Access Compliance Report

Public Rights-of-Way

Intersection ID: 42773	Main Street: ERWIN_RIDGE_AV	Cross Street: SWANSONG_LN	Location: E
ADA ID: 18B94487C4B0	Ramp Type: Perp	Initial Pass/Fail: Pass	Overall Compliance: No
Codes/Mitigation Info/Possible Solution		Field Measurements/Component Compliance	
		Severity Score: 15

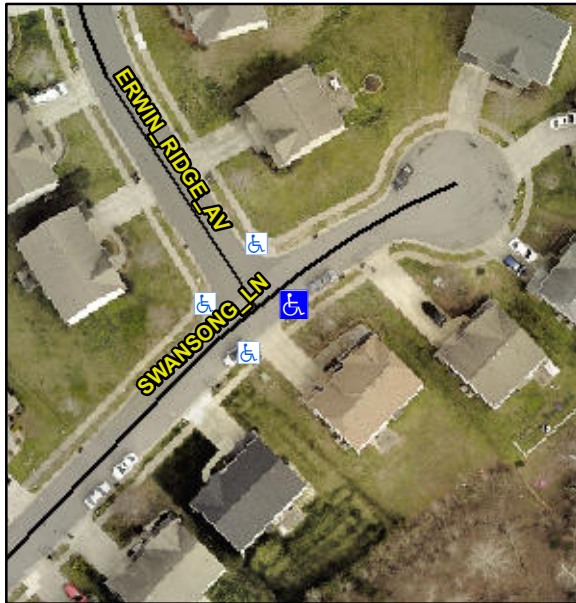
**Remove & Replace Entire Ramp.
Remove & Replace Gutter.**

Not Found, R305, R304.5.4
